ADDENDUM NO. 1

March 22, 2024

FAIRFIELD COUNTY AIRPORT CONSTRUCT 4 BOX HANGARS, 10-UNIT T-HANGAR

BOX HANGAR
 MECHANICAL AND
 PLUMBING PLAN

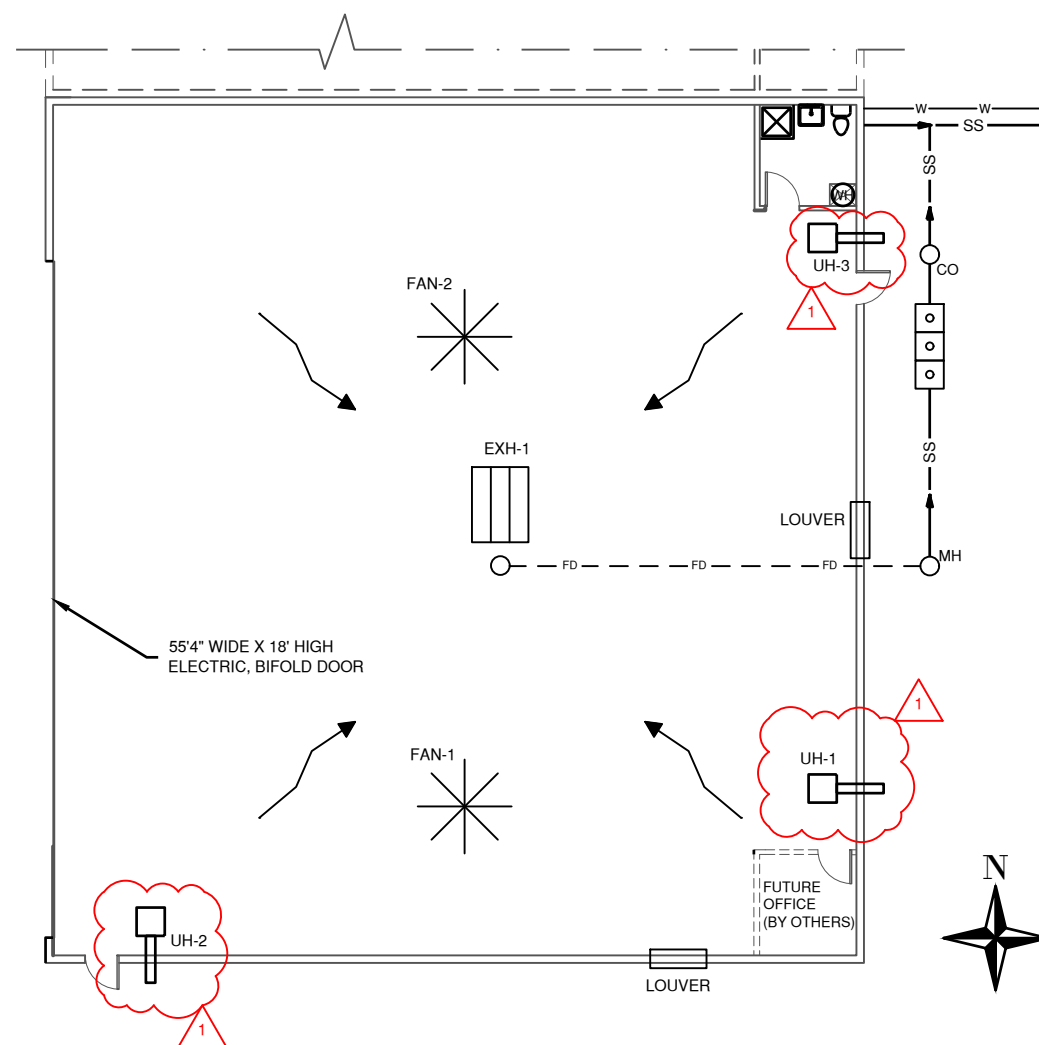
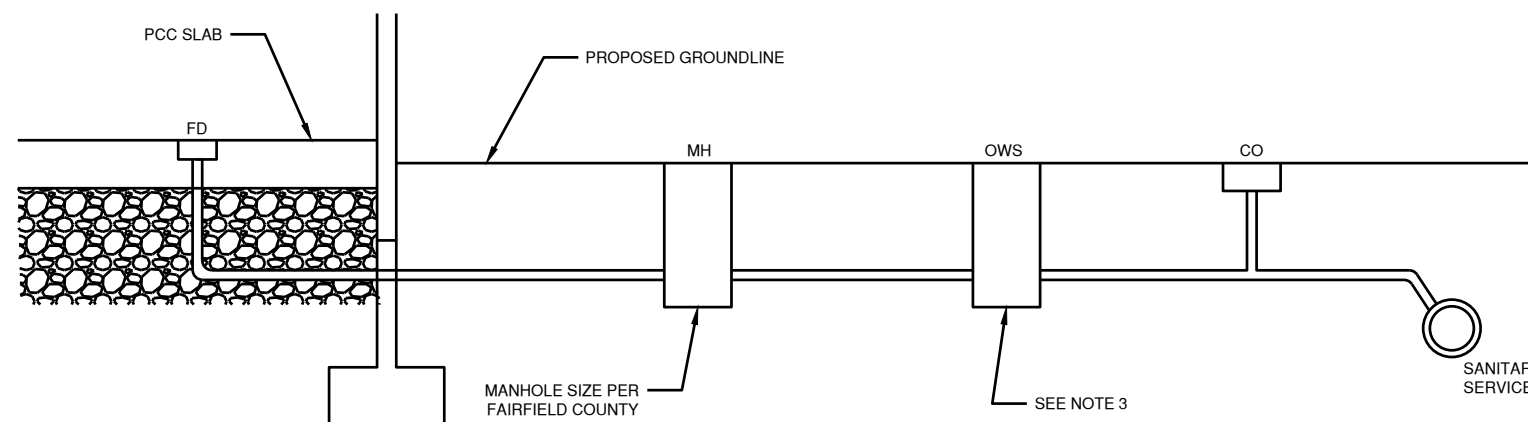
- A. REPLACE sheets 2 and 45 with the included REVISED sheets.
 - a. 2 – Add lump sum heating quantity to the quantities sheet
 - b. 45 – Added Notes 15 and 16

- SEE SITE PLANS FOR UTILITY CONNECTIONS.
- THREE (3) UNIT HEATERS, CEILING MOUNTED, 30,000 BTU MINIMUM EACH, SHALL BE PROVIDED AND INSTALLED, CONNECTED TO INDIVIDUAL THERMOSTATS. AT THE CONTRACTOR'S OPTION, RADIANT HEAT TUBES MAY BE USED IN LIEU OF UNIT HEATERS.

- CONTRACTOR TO COORDINATE GAS SERVICE WITH THE UTILITY BASED ON EQUIPMENT TO BE PROVIDED.
